Design Recommendation Meeting  
6.22.2020  
3033617-EG  
3034294-LU  
809 S Washington St

# EDG RESPONSE

## Soffits

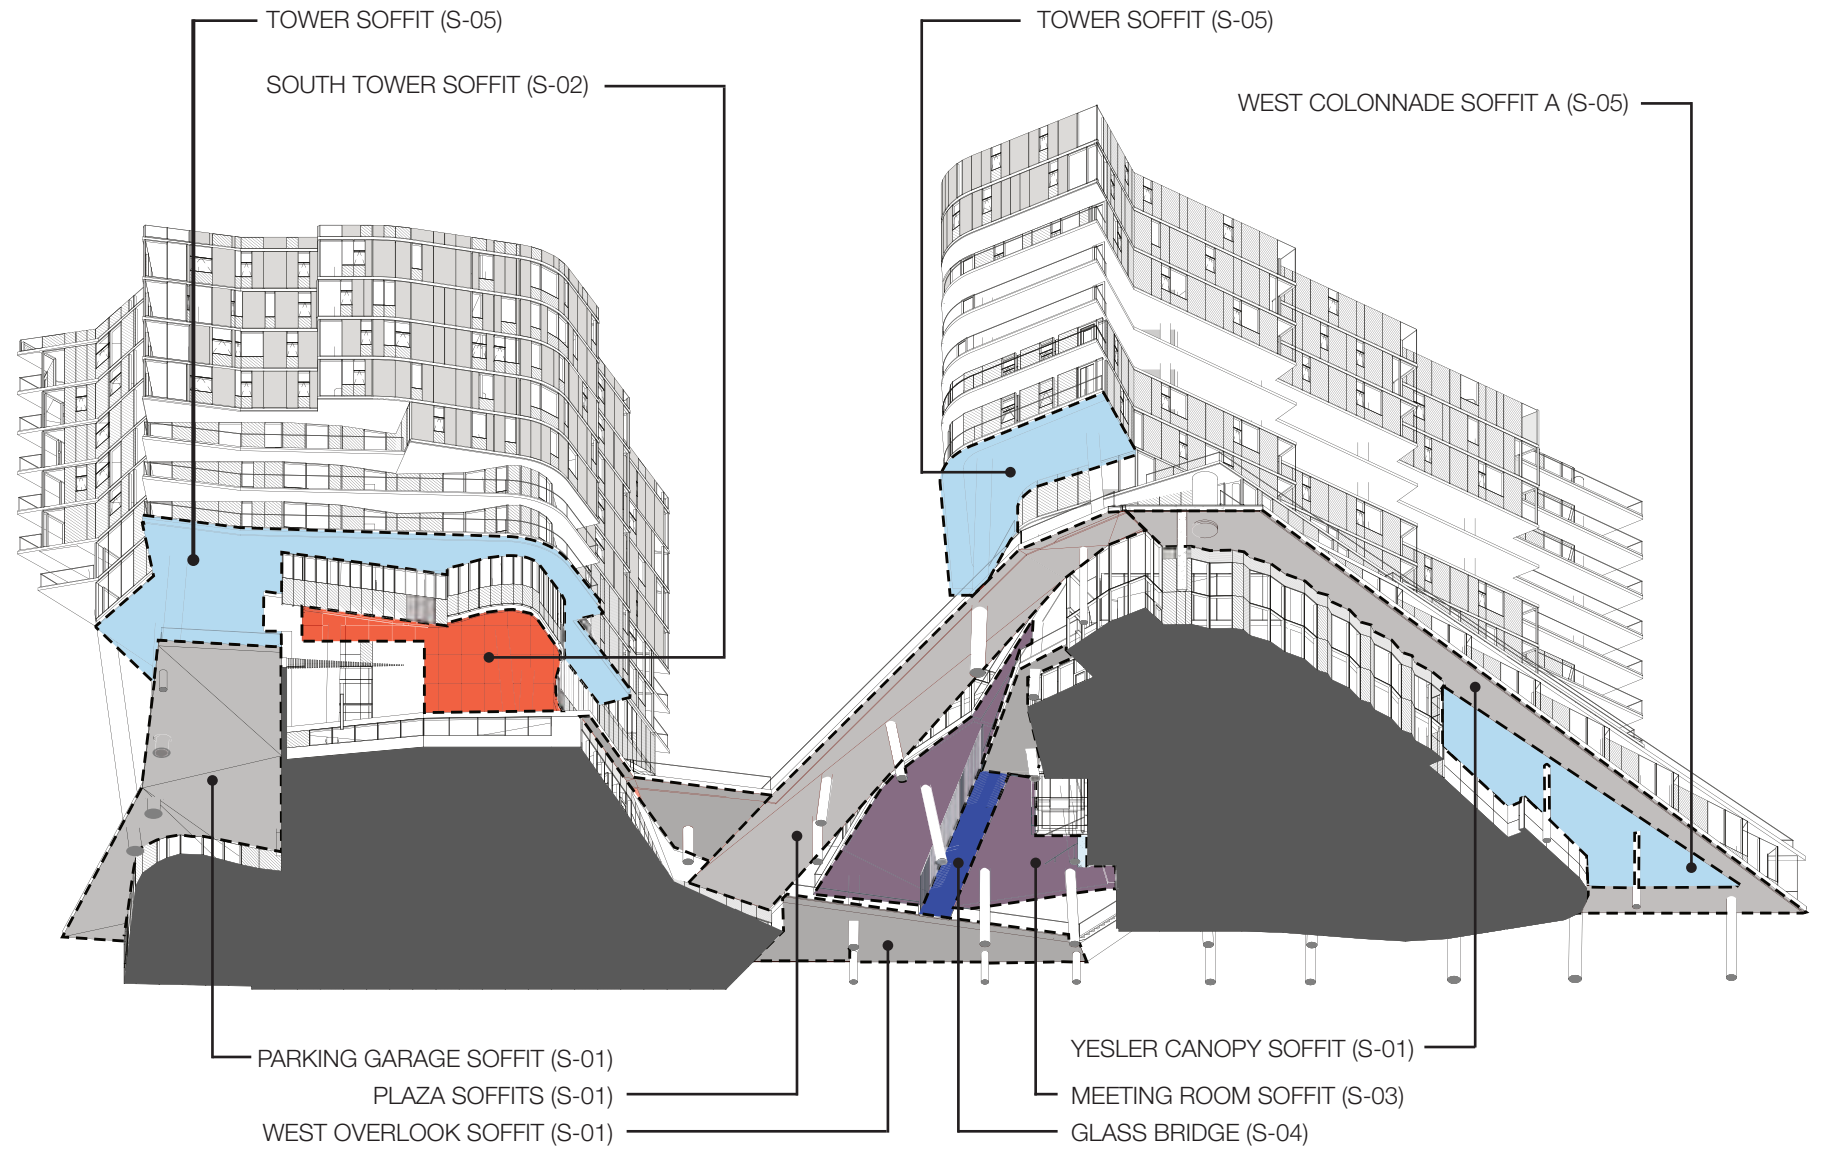
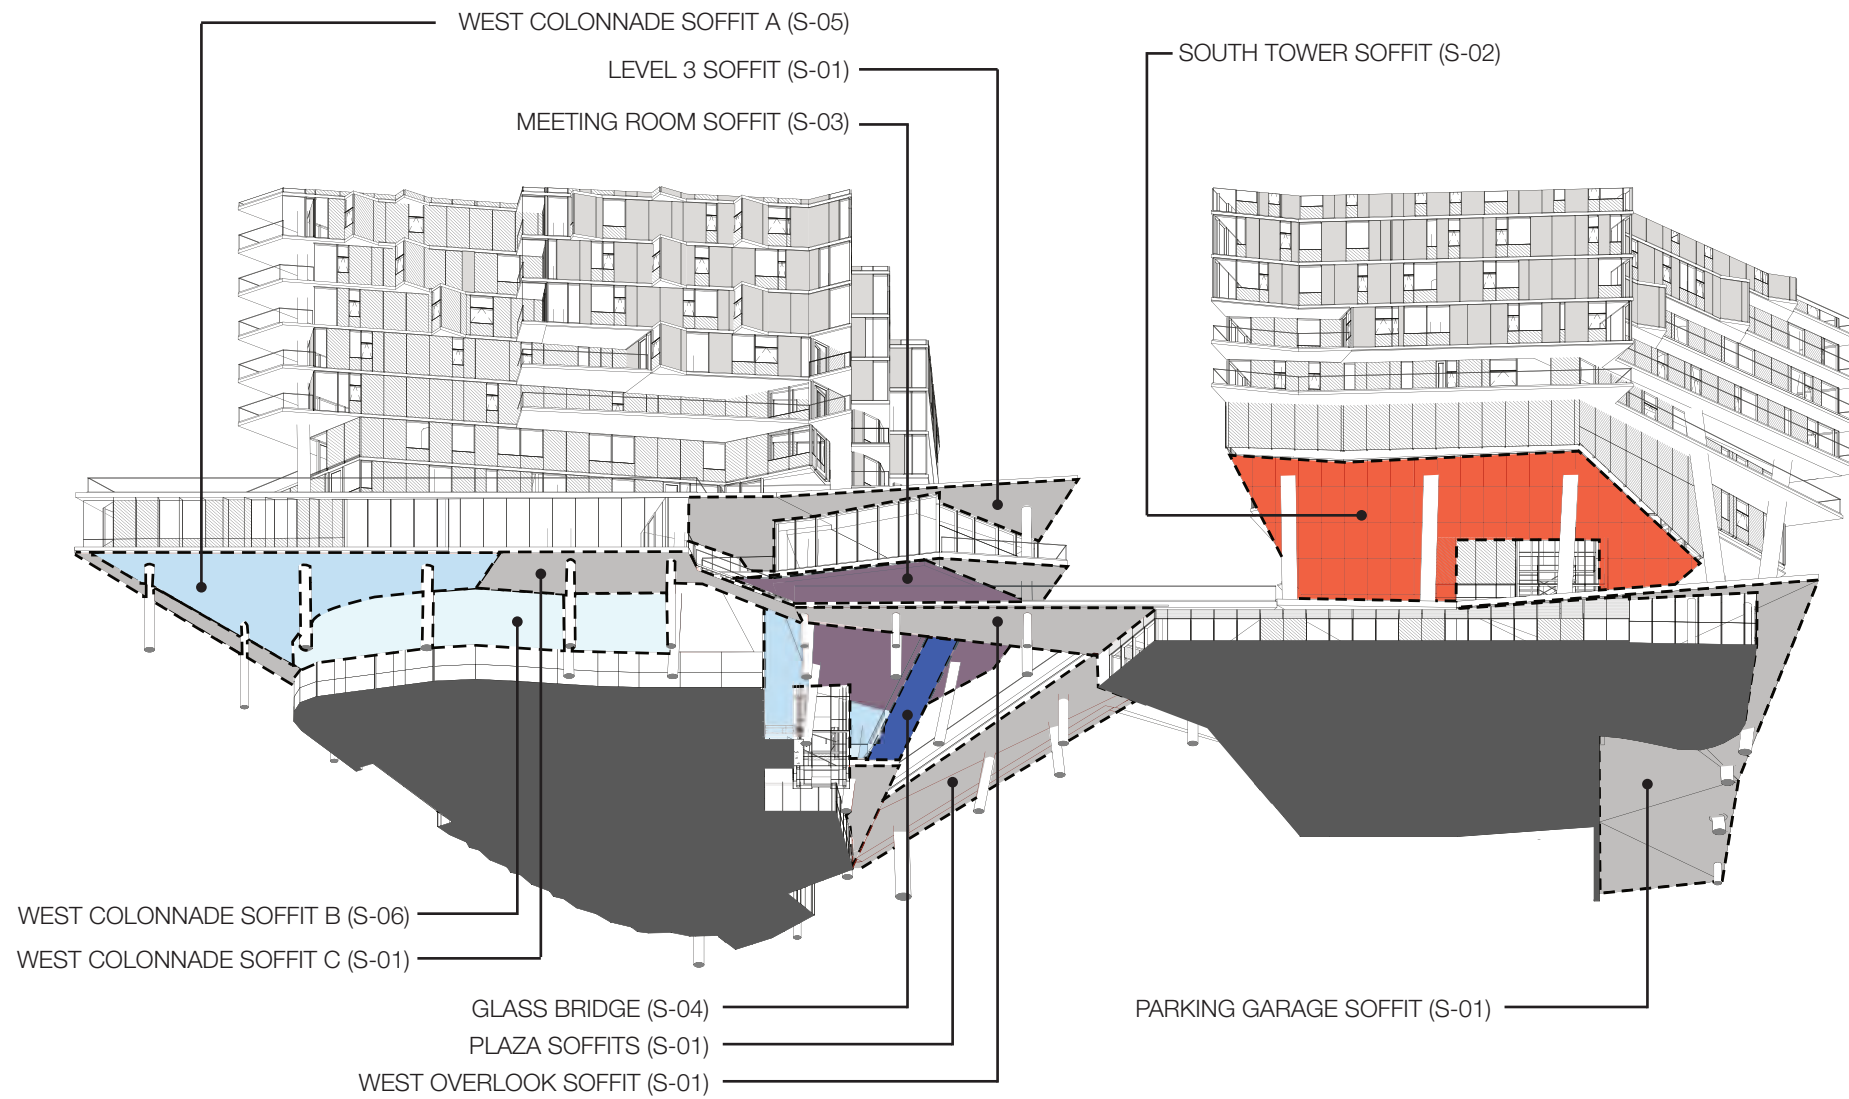
**3A. Soffits:** The Board noted that the views from I5 of phase II revealed that the soffit treatment of the podium will need to be thoughtfully considered as it is highly visible. (Yesler Terrace CS3 Neighborhood Context, PL2-B Safety and Security, Yesler Terrace DC1-C-2. Visual Impacts, Yesler Terrace DC4 Preferred Exterior Materials)

The Applicant acknowledges that the soffits will be visible from I-5 creating an opportunity for strong graphic elements that are legible day and night. The Applicant proposes the soffits include high quality finishes creating a variety of experiences. Materials considered for the soffits are primarily gray-toned to not overwhelm the eye or distract from the glassy towers. In some areas, color highlights are being studied to create “jewel-box” effects. Materials proposed are intended to be durable. The currently proposed material is Gypsum Wall Board as the base-case. Tensile Fabric is preferred for the color highlighted areas. The Applicant is also studying application of Glass, or Metal Panel in lieu of Tensile Fabric to make sure the material will be durable and perform well over time. We are requesting support for all of these material choices at the Recommendation stage so that we can continue development of the materials as the MUP progresses to final approval.

## Parking Garage

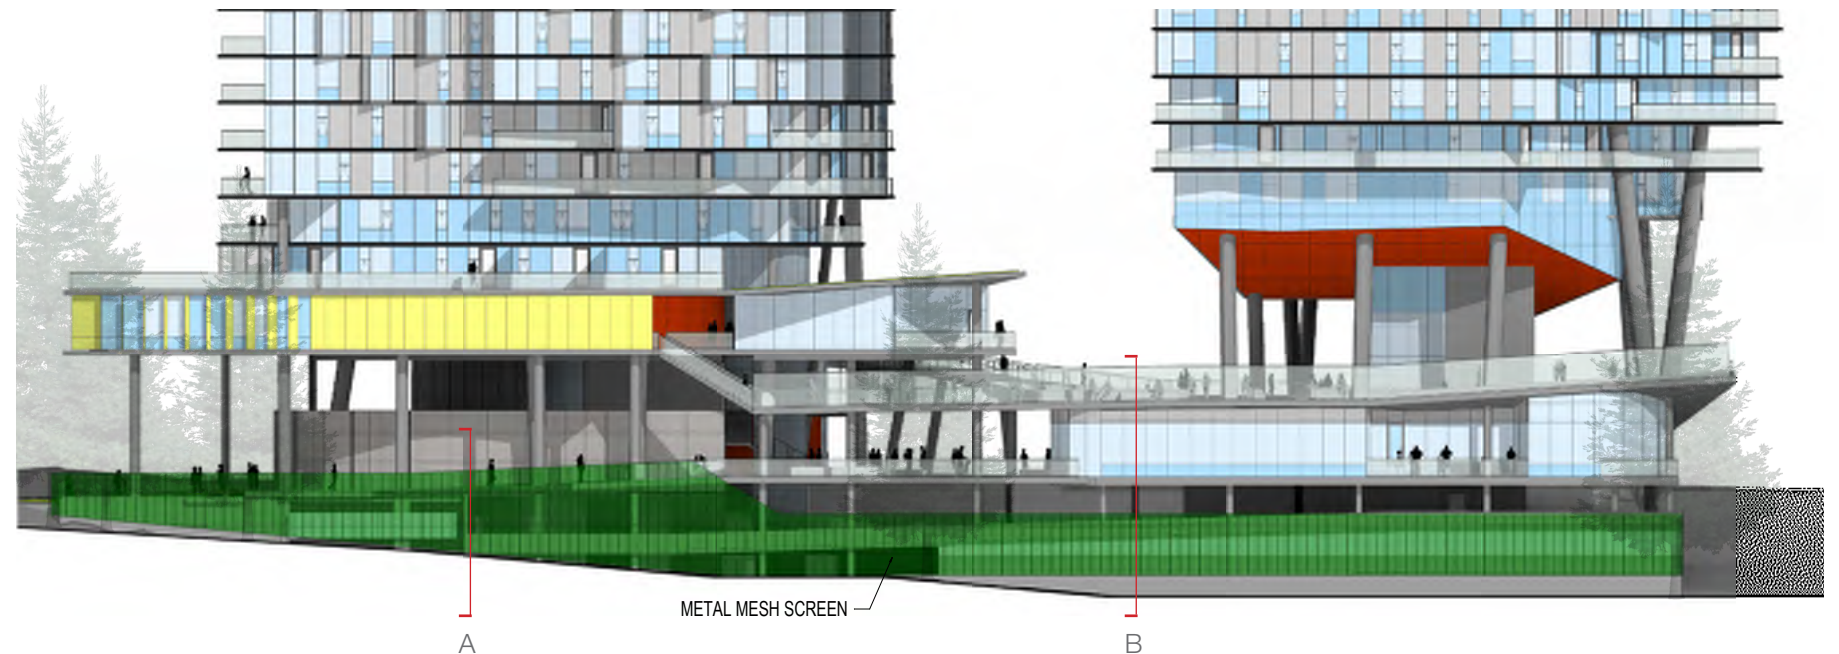
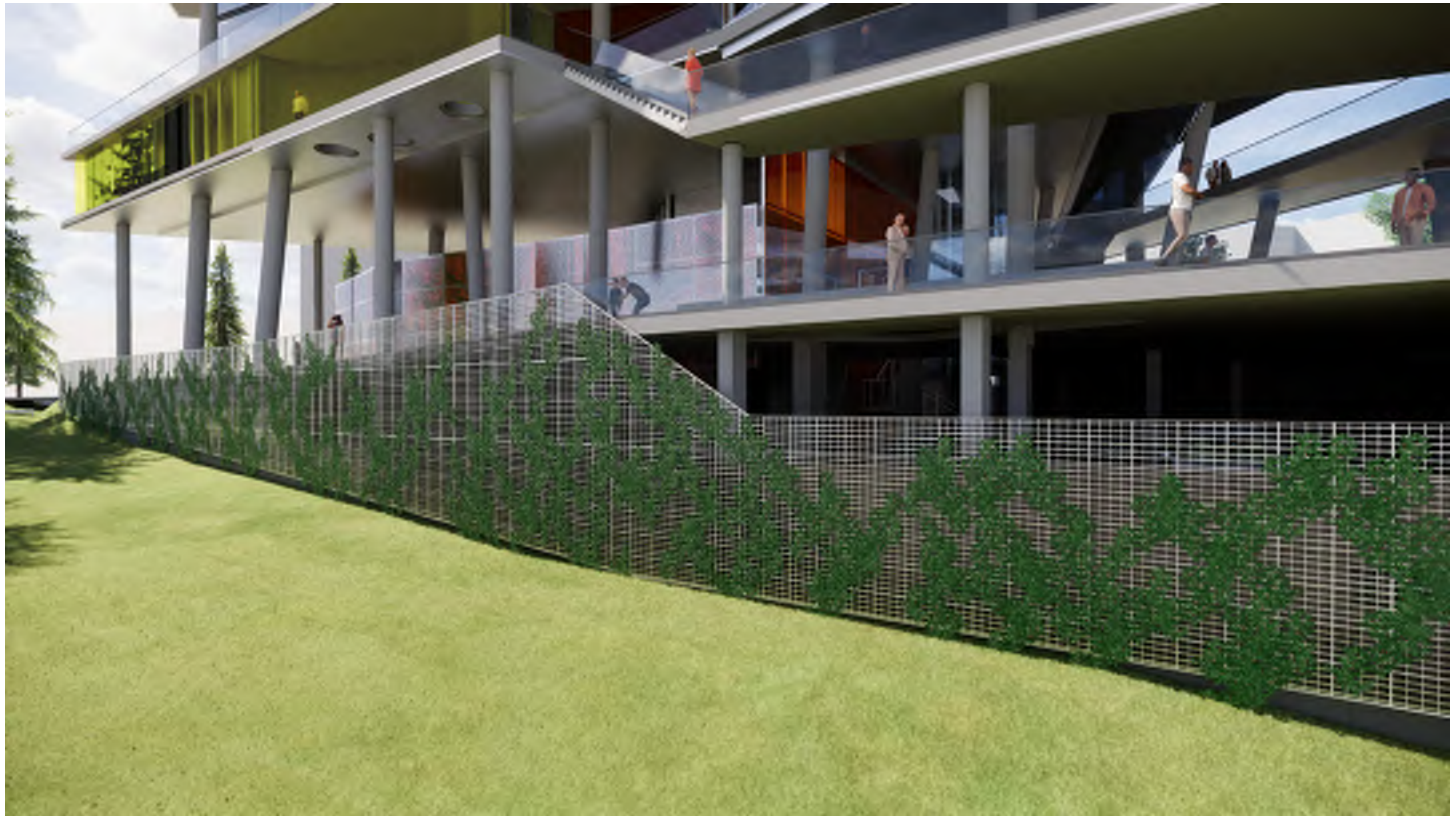
**3B. Planting at Garage Screen:** The Board discussed the vines proposed to screen the garage levels and suggested that the vegetation come from above rather than below so that the effect of the screening is more readily apparent. (Yesler Terrace CS3 Neighborhood Context, PL2-B Safety and Security, Yesler Terrace DC1-C-2. Visual Impacts)

**3C. Parking Garage:** The Board recommend further study of the parking garage so that the design either reads as very porous and transparent or heavy and grounded into the slope. Whichever approach is taken, the design should read clearly from I5 and integrate well into the strong landscape design plan. (DC1-B Vehicular Access and Circulation Yesler Terrace CS3 Neighborhood Context, PL2-B Safety and Security, Yesler Terrace DC1-C-2. Visual Impacts)

A metal mesh partially covers the open parking garage providing both a security screen, and armature for vines to grow on. Visually the mesh creates a transition from the heavy concrete base to the lightweight expression of the podium. Vines rising from the ground reinforces this transition. Options for vines hanging from above were studied and determined to be less effective with respect to plant establishment and long-term vitality. Limitation to soil volume on the raised deck/garage roof restricts plant success. The intent to open views from the plaza to the west is also restricted if vines cover the 42" tall guardrail along the edge of the plaza and further compress the view out from the plaza, and the light that is allowed to enter the space beneath the terrace canopies. Vines planted in the (ground) soil on grade along the west facade will thrive with long term access to good soil volume and drainage.

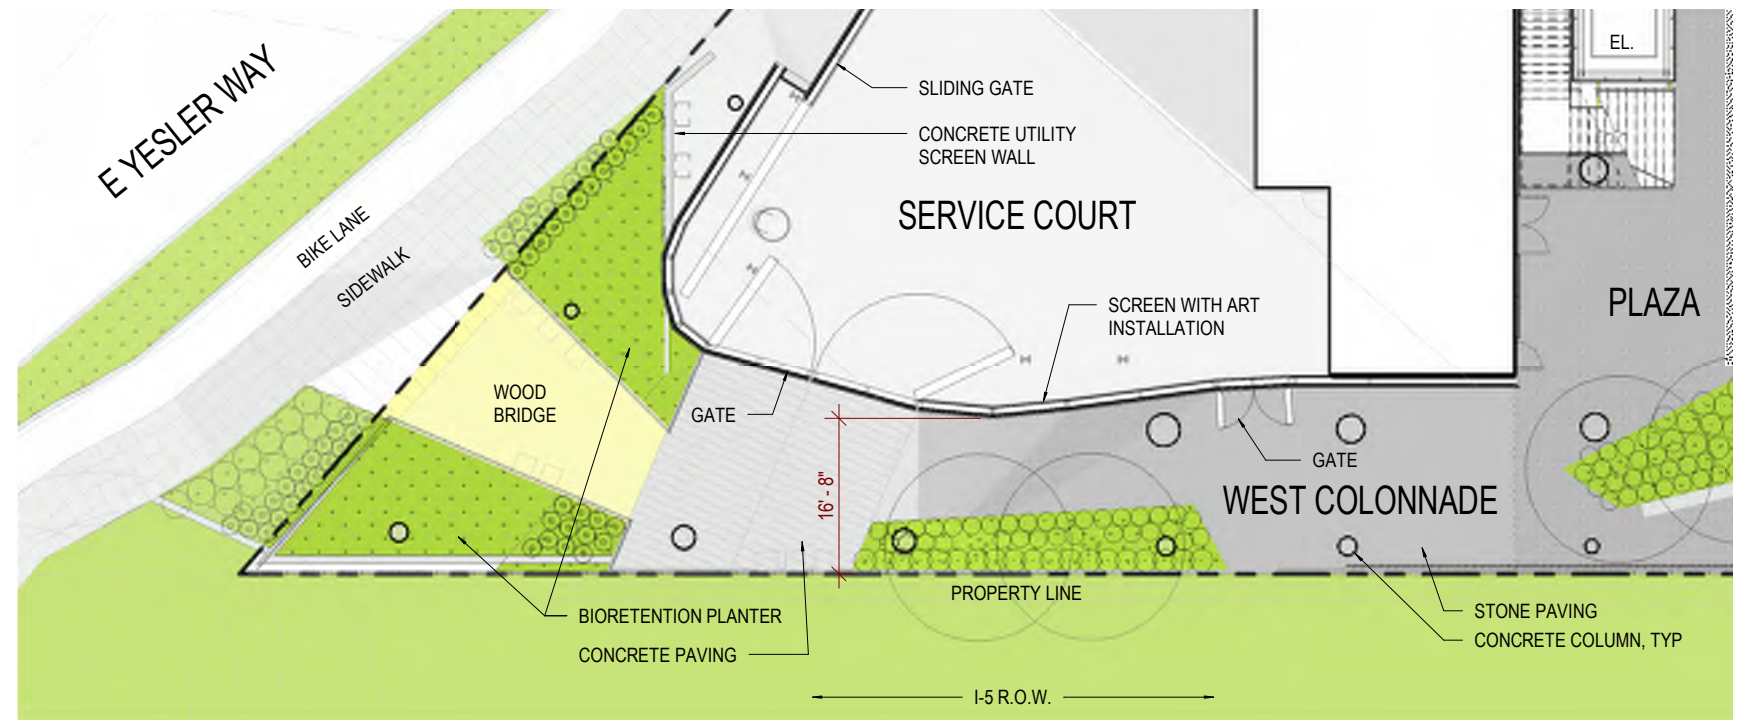
i. The Board noted that the appearance of the service entry on Yesler Way will be critical at this highly visible location.

The Board stressed that this is a gateway location that the tower successfully establishes, but this same level of drama, coherence and interest needs to be carried down to the base at this location. The Board noted the following elements should be considered and addressed at the next meeting (DC1-B Vehicular Access and Circulation and Yesler Terrace Supplemental, Yesler Terrace CS1-E Water, Yesler Terrace CS2 Wayfinding Kiosks, PL1-B-1. Pedestrian Infrastructure):

- ii. Creation of a welcoming space along the street level;
- iii. Thoughtful and interesting design of the screen wall and garage doors/gates;
- iv. Alleviating the pinch point of the prominent building corner against the site corner;
- v. Promotion a safe and secure space;
- vi. Integration of exterior lighting to highlight the podium and this programmatic function;
- vii. Use of high-quality materiality;
- viii. Examine the potential for porosity through this space to the landscaping and views beyond; and
- ix. Explore use of landscaping and/or art to achieve the guidance above.

**B. Street Level Perspectives:** At the next meeting, the Board requested perspectives taken from the pedestrian level on the same side of the street (Yesler) as the subject site to really understand the space, views and sight lines. (DC1-B Vehicular Access and Circulation and Yesler Terrace Supplemental) Comment 6.c

Pedestrians will access the west edge of the site from Yesler Way via the wide accessible bridge over the bio-retention planter that introduces the on-site stormwater strategy along the edge of the public sidewalk. The colonnade will be an open double height space, welcoming the public into the podium. A partial height art installation screens the service court from the pedestrian areas, and provides a visual connection from the ROW to the Central Plaza. In contrast to the articulated screen, a smooth light gray GWB soffit reflects light into the space reinforcing the open airy quality.

## Follies

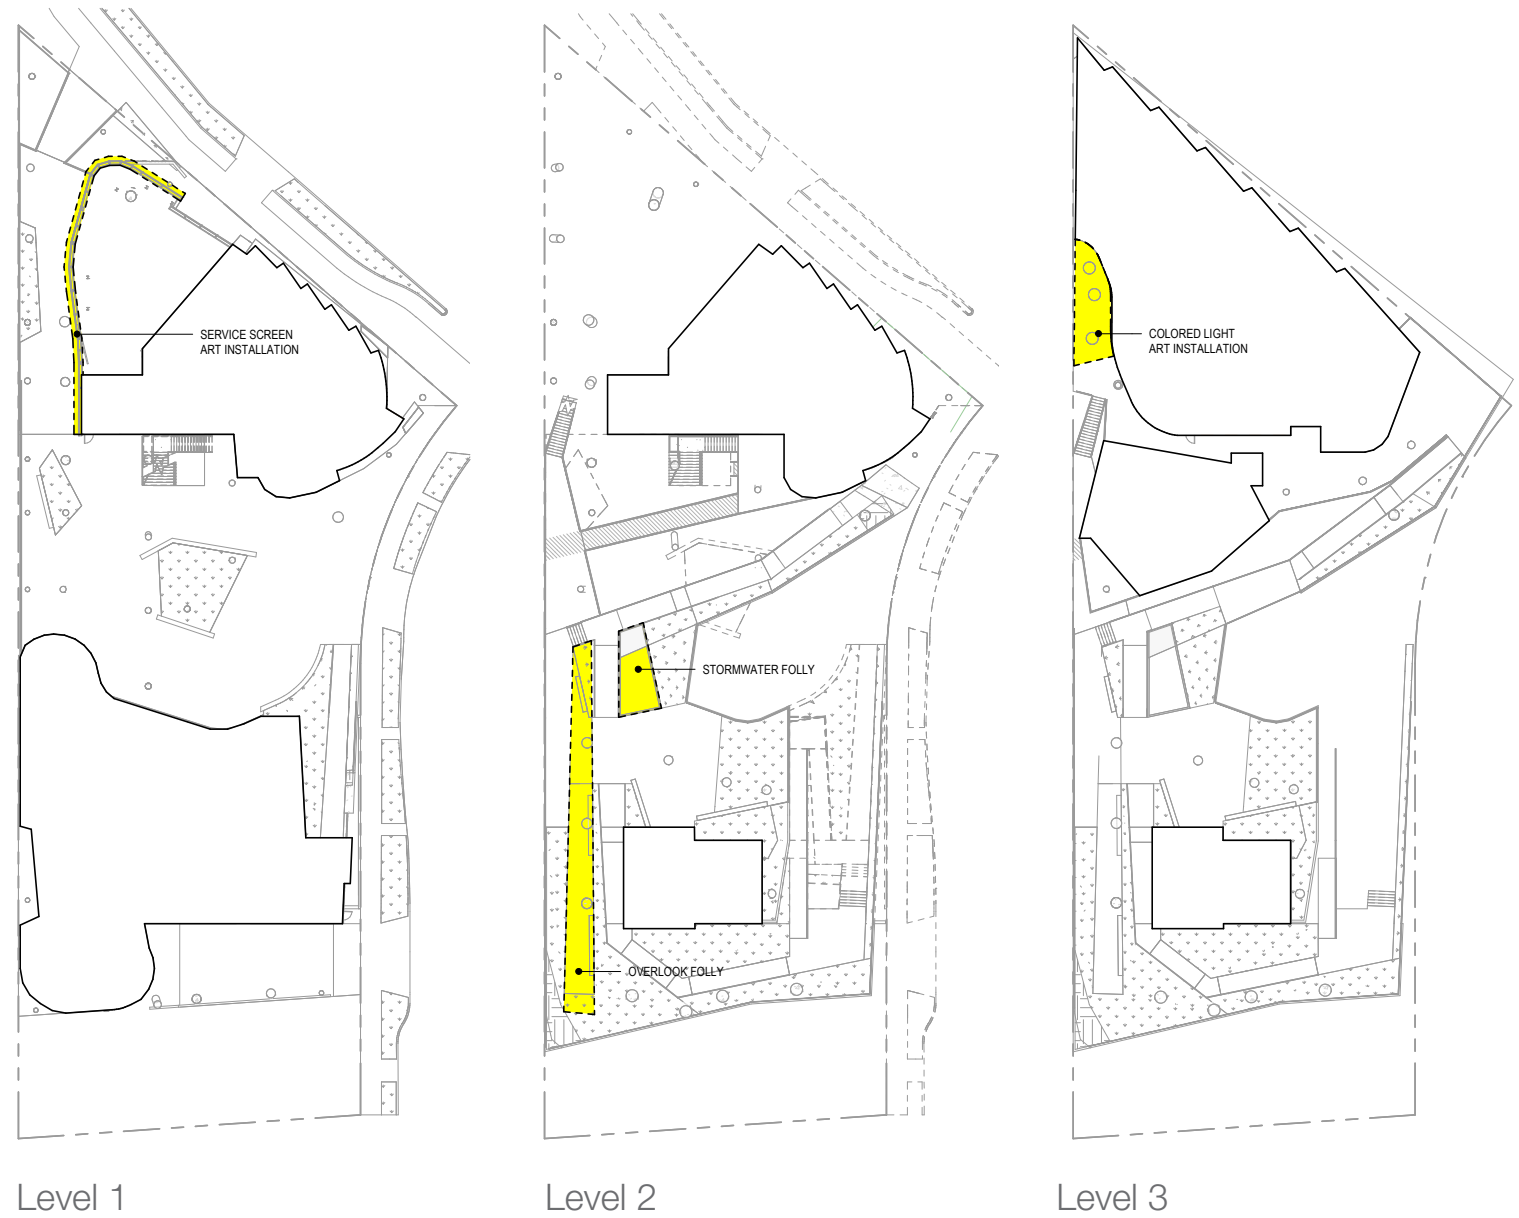
**7A. Follies:** The Board agreed that the details of the folly concept within the landscape plan were exciting and should be further explored and details at the next meeting. Specific information about the curation and themes will be critical. The opportunity for these elements to integrate cultural history of the neighborhood, as well as introduce playfulness and learning should be harnessed. The Board echoed public comment and noted that the cultural references expressed in the landscape design and folly elements should strive to reflect both the past communities of the neighborhood, as well as the present and future. (Yesler Terrace CS1-E Water, Yesler Terrace CS2 Wayfinding Kiosks)

At significant moments within the podium, follies will be introduced to enrich peoples experience, creating opportunities to heighten or change perceptions of natural phenomena, of time and place, or of the history of the site. These follies will encourage residents and the public to engage the building and landscape with moments of mystery, humor, and delight, and with each visit, a new and more complete understanding of place can emerge.
